## 2 SITE CHARACTERISTICS

### 2.0 North Anna 3 Site

This chapter of the U.S. Nuclear Regulatory Commission's (NRC's) safety evaluation report (SER) provides the NRC staff evaluation of the North Anna 3 Combined License (COL) Final Safety Analysis Report (FSAR) which addresses the geological, seismological, hydrological, and meteorological characteristics of the site and vicinity, in conjunction with present and projected population distributions and land use and site activities and controls.

**Figure 2.5.1-4. NAPS Geologic Field Reconnaissance after the 2011 Mineral, VA, earthquake showing traverse routes, waypoints and the LiDAR survey boundary (from FSAR Figure 2.5.1-204, Rev. 9)**

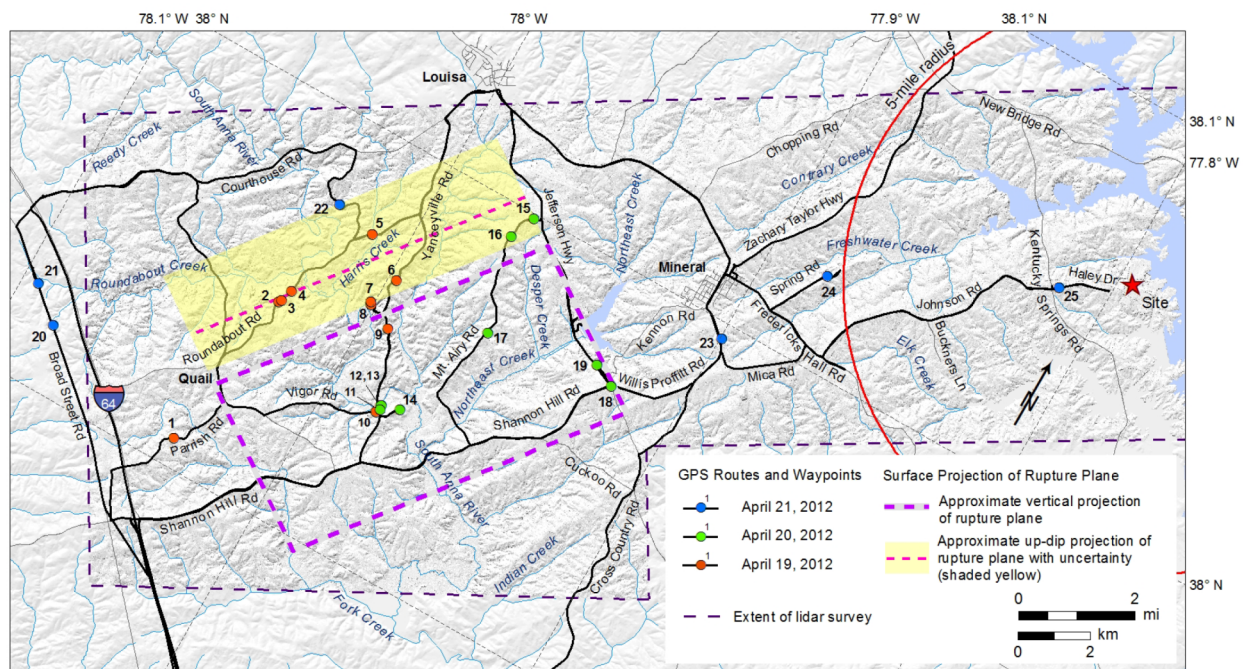
- a) At each waypoint, what was examined and what is its significance.
- b) Provide a high resolution LiDAR map (scale ~1:10,000) for areas immediately west of North Anna 3 where fault 'a' might be located, such as waypoint sites 23, 24, and 25.
- c) Discuss longitudinal stream profile analysis completed in the epicentral area. Discuss any anomalies revealed by this analysis that could indicate subtle tectonic deformation in the hanging wall of the Quail fault, such as gradient changes, offset stream terraces, elevated topography.
- d) Explain how you evaluated the Quaternary geology of the epicentral area and the distribution, correlation and elevation of river terraces on the South Anna River. Discuss any indication of subtle surface uplift in river terraces on the hanging wall of Quail fault that might indicate prolonged or repeated surface deformation.

In a June 10, 2014, response to RAI 02.05.01-5a and b (ADAMS Accession No. ML14177A441), the COL applicant provided a table with details for the significance of each waypoint visited during the field reconnaissance program. Observations at some of the waypoints confirm

**Figure 2.5.1-8. Stream Profiles with Geology of Burton et al. (2014) from FSAR Figure 2.5.1-217 and -219, Rev. 9**

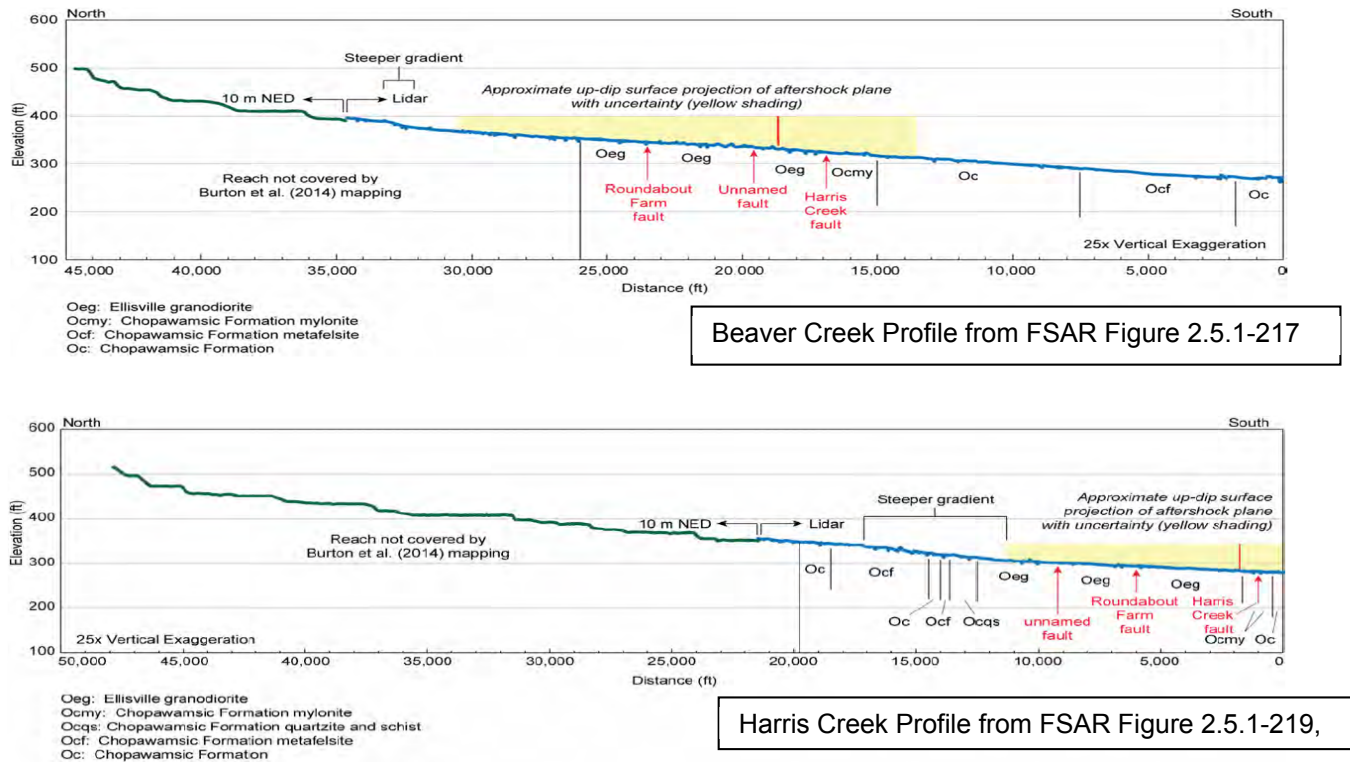
In a September 30, 2014, response to RAI 02.05.01-8c (ADAMS Accession No. ML14274A303), the COL applicant stated that a subtle gradient change lies near a 20 percent increase in drainage area due to confluences of Roundabout and Harris Creeks, and upstream of a 17 percent increase in drainage area due to confluences of Beaver and Northeast Creeks and provided a new figure for the South Anna River profile with drainage area increases (RAI 02.05.01-8 Figure 11). The staff notes that Dominion considered and performed additional assessments on some profiles, such as stream gradient (SL) index (Hack, 1957), slope versus distance, and drainage basin versus distance (for South Anna River only) but these methods did not provide useful results for evaluating the subtle anomalies due in part to the extremely low gradient of the streams and the high-frequency (HF) data noise (Figure 2.5.1-8).

**Figure 2.5.2-7. Map of Changes in Seismicity Rates and B-Values for CEUS-SSC Source Zone ECC-AM, Case A (Figure from Applicant Response to RAI 2.5.2-7.)**

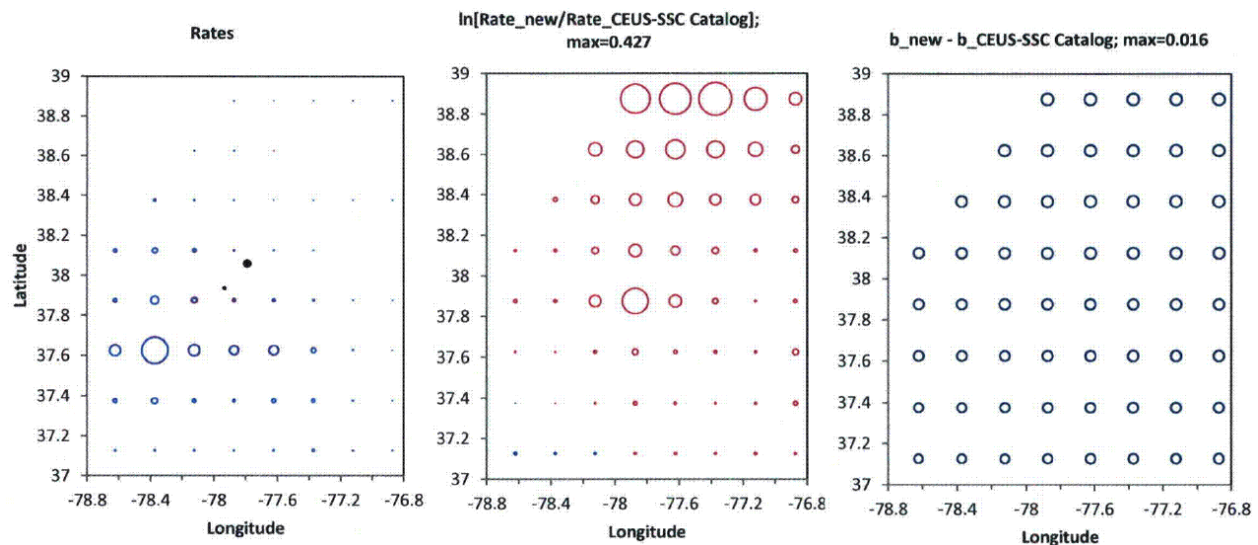
In the response to RAI 2.5.2-7 dated May 9, 2014 (ADAMS Accession No. ML14140A087), and supplemented on May 29, 2014 (ADAMS Accession No. ML14150A439), the applicant provided detailed information about how the updated seismicity catalog influenced rates and b-values in the CEUS-SSC and provided the requested comparison of hazard. The applicant provided plots (example shown on Figure 2.5.2-7 of this SER) of updated rates and b-values for the four distributed seismicity zones that the North Anna 3 site lays within (ECC-AM, MESE-N, MESE-W, and STUDY-R). Further In its response to RAI 2.5.2-7, the applicant provided a Table-1 and a Figure-13, comparing the updated and the baseline seismic hazard at a variety of input spectral acceleration levels. The applicant demonstrated that the updated seismic catalog increases hazard at the North Anna 3 site up to 9 percent for annual frequencies of exceedance lower than  $10^{-4}$ .

Based on the applicant's response, the results of staff's site audit and its independent confirmatory analysis, staff considers RAI 2.5.2-7 resolved and closed.

**Figure 2.5.2-8. Comparison of the Applicant's Base Rock Hazard Curves with the Results of the Staff's Confirmatory Analysis**

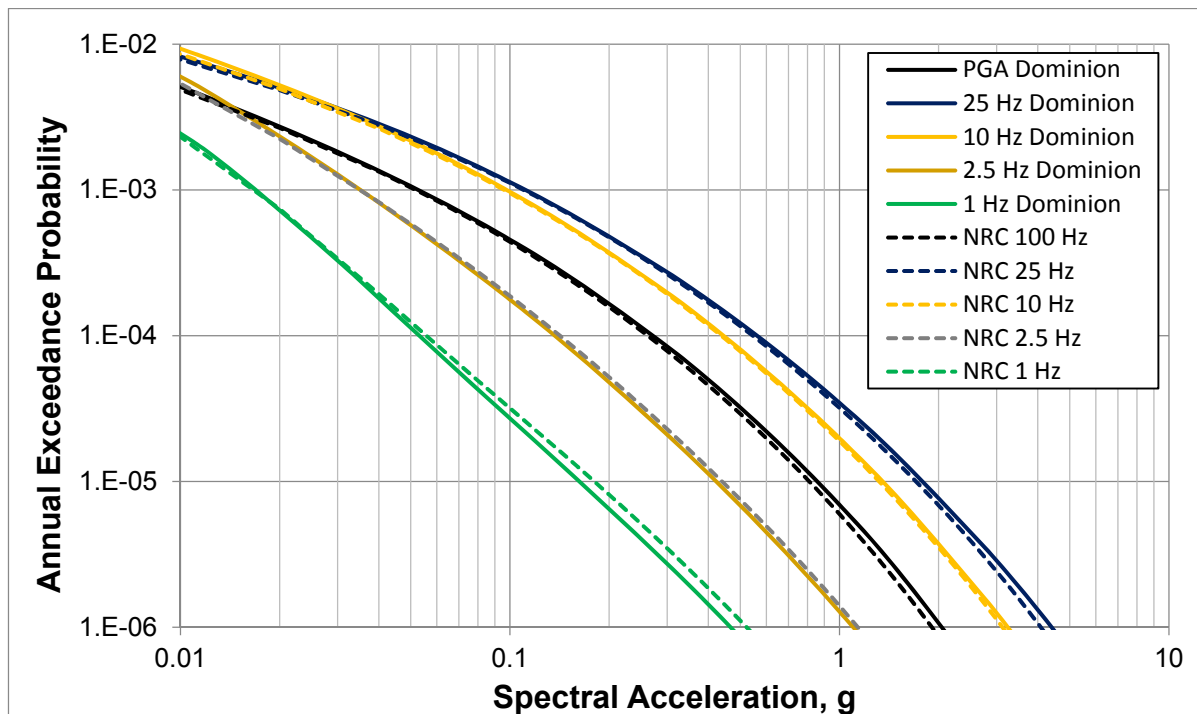
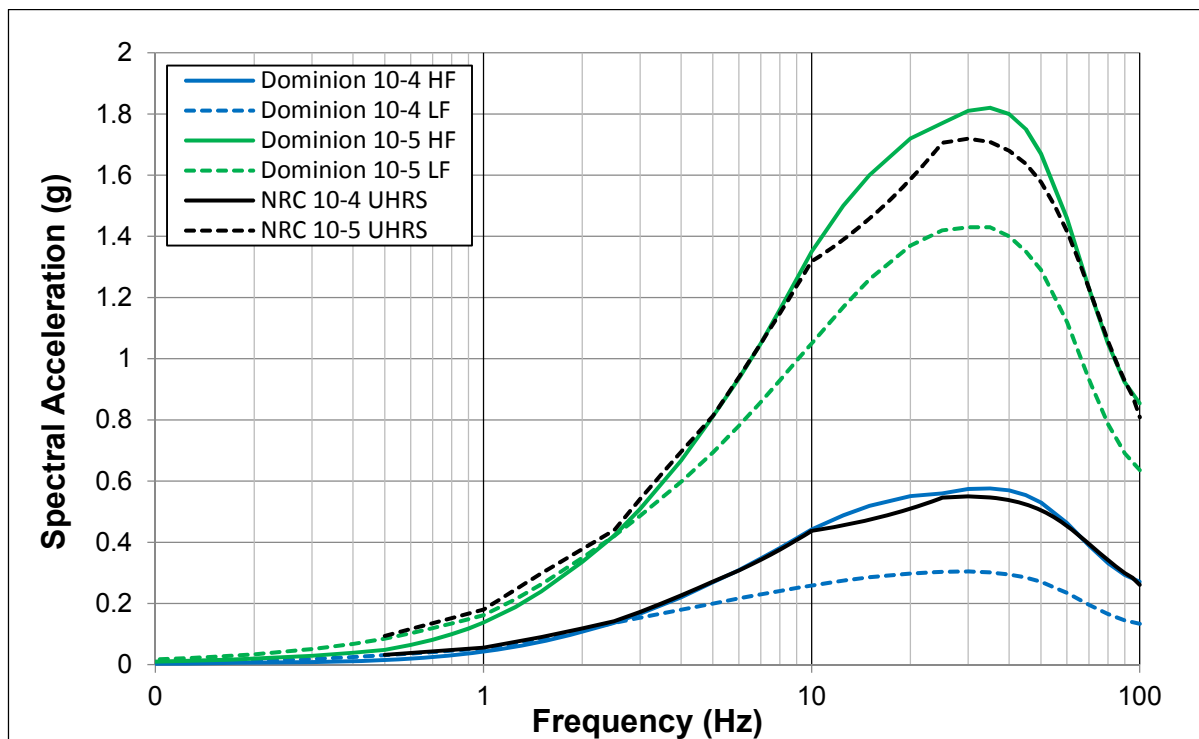
The staff also conducted an independent confirmatory analysis of the PSHA. The staff calculated the hazard at the North Anna 3 site using the published CEUS-SSC for distances up to 500 km (310 mi) for distributed seismicity sources and 1,000 km (620 mi) for RLME sources. In its confirmatory analysis, staff used the EPRI (2013) GMM. Figure 2.5.2-8 of this SER compares the PSHA results from the staff's independent confirmatory analysis with those of the applicant for PGA and frequencies of 25, 10, 2.5, and 1 Hz. The staff's and the applicant's calculations are in acceptable agreement. The staff used its independent PSHA results to develop site specific UHRS at the  $10^{-4}$  and  $10^{-5}$  exceedance frequencies. SER Figure 2.5.2-9 compares  $10^{-4}$  and  $10^{-5}$  UHRS developed by the staff with those developed by the applicant. Because the UHRS results developed by the staff are in acceptable agreement with those developed by the applicant and the applicant has incorporated seismicity after the publication of the CEUS-SSC, including the Mineral earthquake, the staff finds the applicant's PSHA acceptable.

**Figure 2.5.2-10. Comparison of the Applicant's Site Amplification Function with the Results of Staff's Confirmatory Analysis**

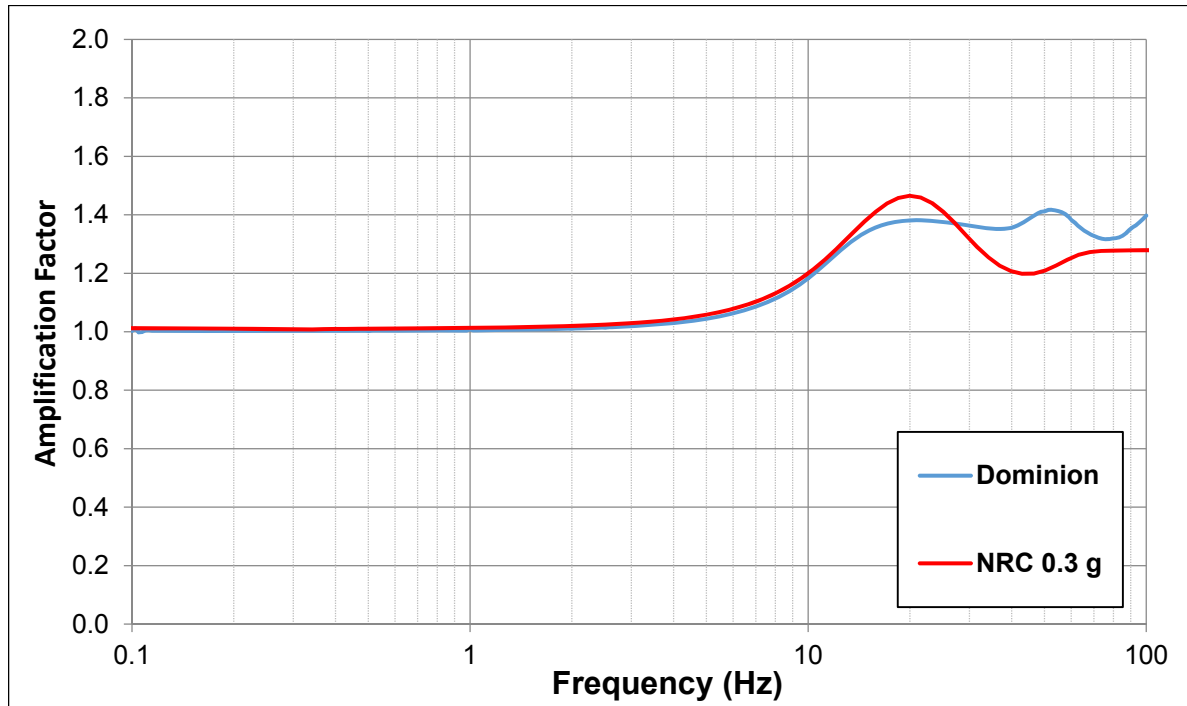
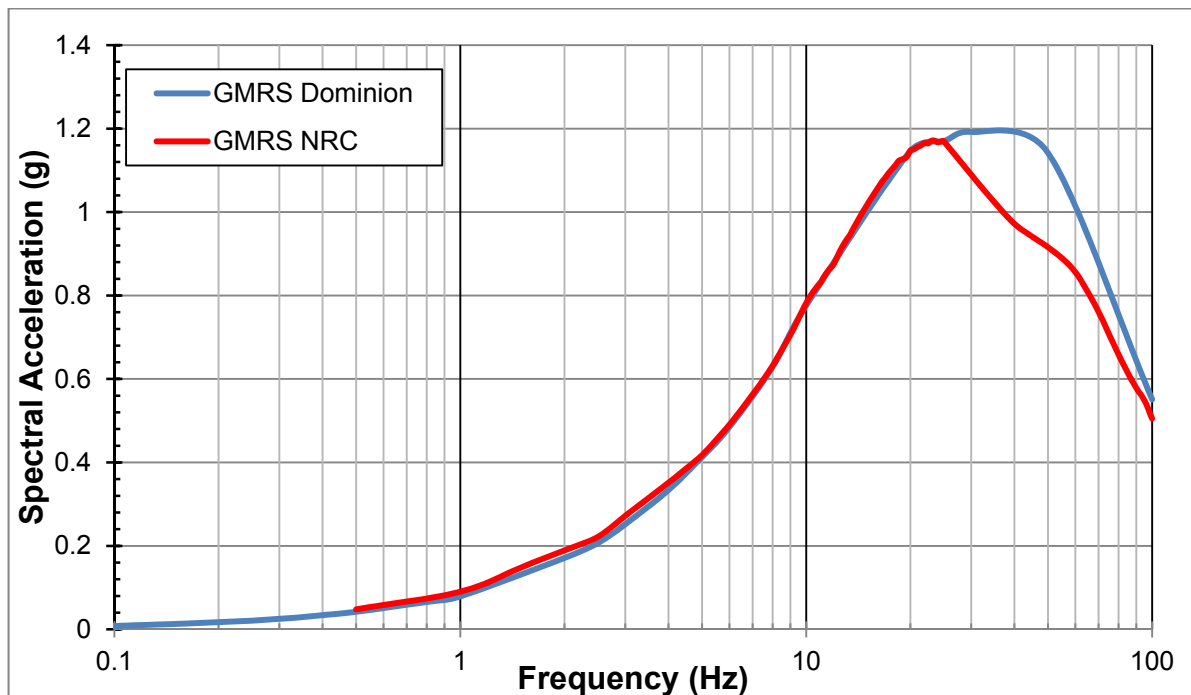
The staff performed a confirmatory analysis of site response using values reported by the applicant for geophysical parameters. The staff independently developed BE velocity profiles, randomized the velocity profile and shear modulus degradation and damping curves and calculated site-specific amplification functions at the GMRS elevation. Figure 2.5.2-10 shows a comparison of amplification functions developed by the staff with those developed by the applicant. The differences in site amplification functions calculated by the staff and the applicant are not significant considering that staff used Approach 3 and the applicant used Approach 2, as described in NUREG/CR-6728, for the site response calculations. The staff subsequently combined its PSHA results at the  $10^{-4}$  and  $10^{-5}$  exceedance frequencies with its amplification functions and calculated a site-specific GMRS. Figure 2.5.2-11 shows a comparison of the site-specific GMRS developed by the staff with that developed by the applicant. The applicant's

Based on the applicant's response to RAIs related to the site response calculations and staff's independent confirmatory analysis that is consistent with the applicant's results, the staff considers RAI 2.5.2-2, RAI 2.5.2-3, and RAI 2.5.2-6 resolved and closed.

**Figure 2.5.3-1. LiDAR-derived hillshade map showing locations of key North Anna 3 borings and surface mapped (Mixon et al, 2000) and trench mapped (Dames and Moore, 1973) representations of fault 'a' (from Response to RAI 2.5.1-6d, Figure 1)**

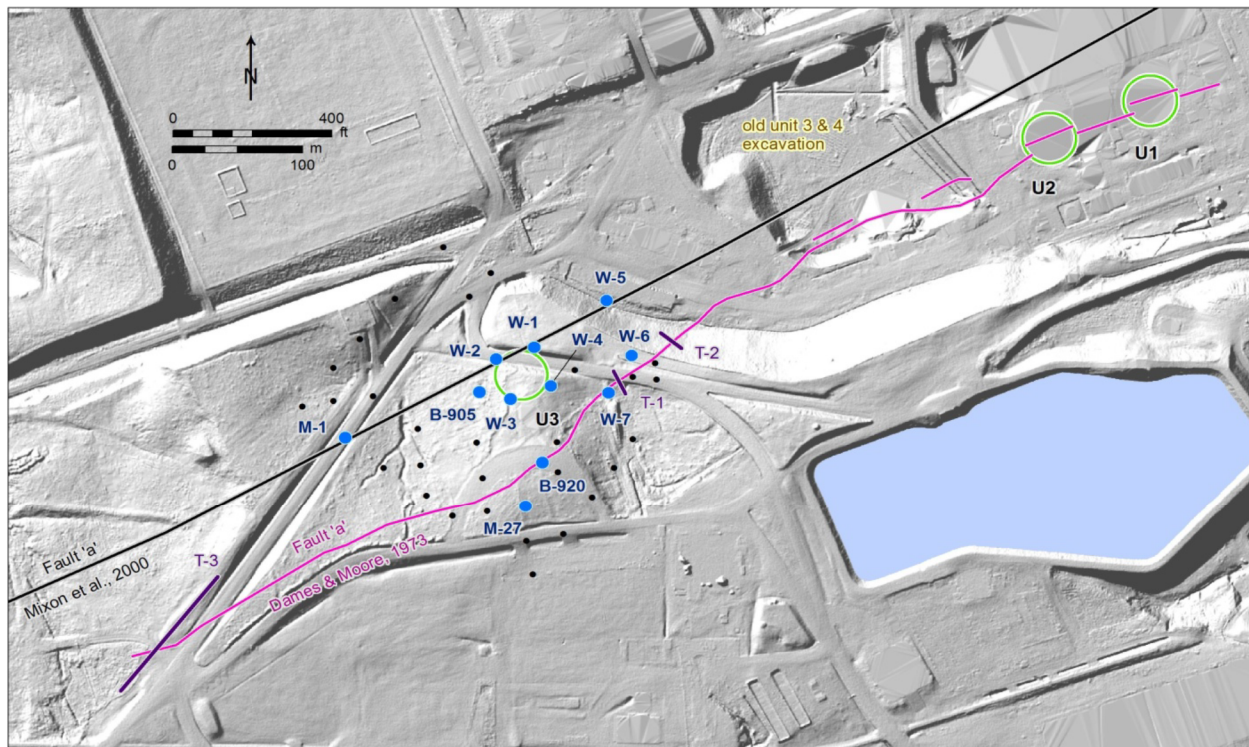
The staff reviewed several Dames and Moore reports from the 1970's regarding fault 'a' (VEPCO, 1974; 1973) in addition to the findings in the ESP SER regarding fault 'a' (NUREG-1835). The shear zone observed in W-1 and W-5 has similar features to fault 'a' but at a much less significant scale. Because the micro-shear zone in W-1 and W-5 is located northwest of fault 'a' and likely also dips northwest, it is structurally higher than fault 'a' (Figure 2.5.3-1 of this report). The staff notes that significant tectonic structures such as fault 'a' typically have a zone of deformation and deformation fabric is not necessarily limited to a single fault plane so the micro-shear zone could be associated with fault 'a'. Regardless of a structural association or not, the deformation associated with fault 'a' was determined to be geologically old, greater than 1 million years old. The staff considers the shear zone in W-1 and W-5 likely to be the same age as fault 'a' and not a potential future surface deformation hazard to the site.

The staff reviewed DCD COL Item 2.0-28-A, which states the ESBWR design requires the applicant to demonstrate that there is no potential for permanent ground deformation at the site area. The staff concludes that the additional information from additional borings in the site area in conjunction with response to RAI 02.05.01-6c, that provides clarification regarding the possibility of finding major shear zones in the borings as opposed to determining specifically Quaternary fault movement, that there is sufficient subsurface information to resolve DCD COL Item 2.0-28-A. Accordingly and in compliance with 10 CFR 100.23 and 10 CFR 52.79, the staff considers RAI 02.05.01-6c resolved and closed.

**Figure 2.5.4-8. Unit 3 Boring Locations (FSAR Figure 2.5.4-217)**

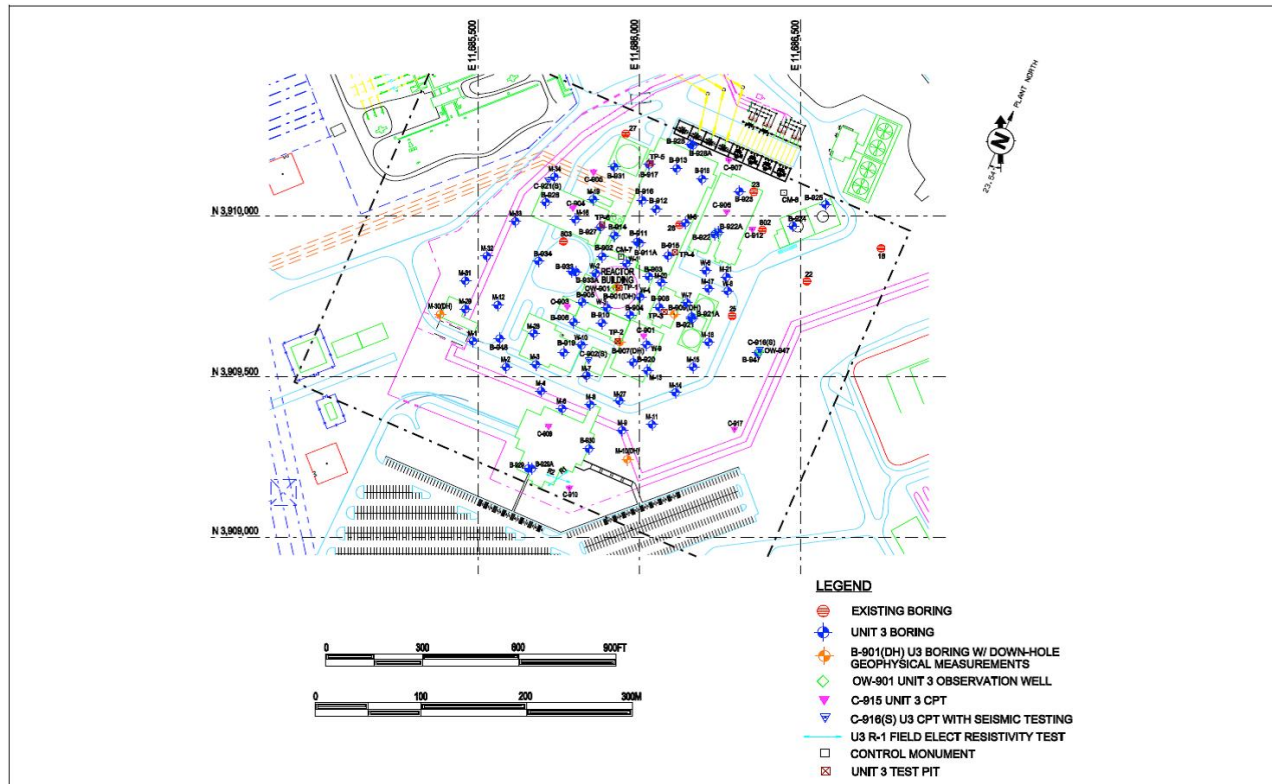
The applicant included several figures that show the subsurface profiles with the cross sections of foundation structures superimposed for comparison. SER Figure 2.5.4-8 shows the locations of the exploration points at the North Anna 3 site. Because the applicant included the plot plans and profiles that compare the foundations of seismic Category I structures to the subsurface profiles at the North Anna 3 site, the staff concludes that the applicant provided sufficient information to satisfy the requirements of ESP COL Action Item 2.5-2. Accordingly, the staff considers ESP COL Action Item 2.5-2 resolved.
